PROPOSED CHANGE TO THE
OPERATING LICENSE

- REVISIONS TO TS 3.8.1.1 & 3.8.1.2 -

(GGNS PCOL-90/13)

A. SUBJECT

Diesel Generator Fuel Oil Storage Tank - Division I & II -

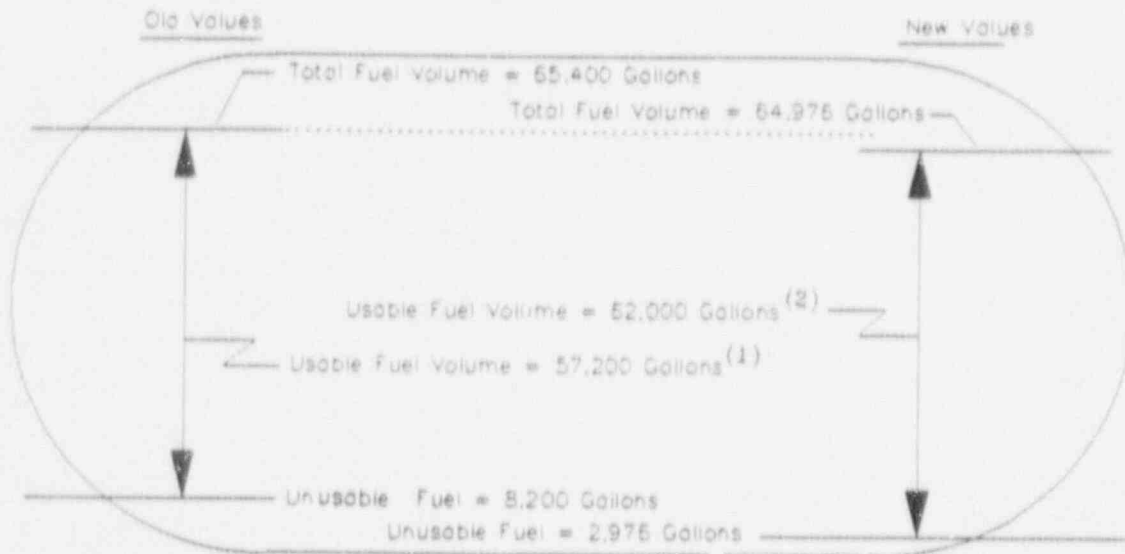
4. The unusable volume is the amount of fuel oil required to ensure adequate fuel oil transfer pump NPSH (4 inches above pump centerline) plus the volume of fuel oil beneath the centerline of the pump suction (8 inches off the tank bottom). Therefore, there is 1 foot of unusable fuel in the bottom of each storage tank. In the old calculations a value of two feet was used for the unusable fuel oil level.

5. The existing Technical Specification fuel oil storage requirements of 57,200 gallons for Divisions I and II and 39,000 gallons for Division III were based on an unusable volume of 8,200 gallons of fuel in each of the tanks. This results in total fuel oil storage requirements for Divisions I and II of 65,400 gallons and 47,200 gallons for Division III. The unusable volume of fuel in each of the tanks was recalculated to be 2,976 gallons. Therefore, even though the minimum required usable volumes (i.e., Technical Specification limits) increased, the existing total fuel oil storage surveillance procedures (considering the new unusable volume of 2,976 gallons) were and are adequate to ensure a sufficient volume of fuel oil exists to operate the diesel generators for seven days.

3. As indicated in the Bases for TS 3.8.1.1 and 3.8.1.2, the fuel oil quantity specified in the Technical Specification is the "usable fuel", not the minimum fuel (i.e., usable plus unusable volumes) in the storage tanks. The proposed TS volume values are the calculated minimum usable volume values rounded up.
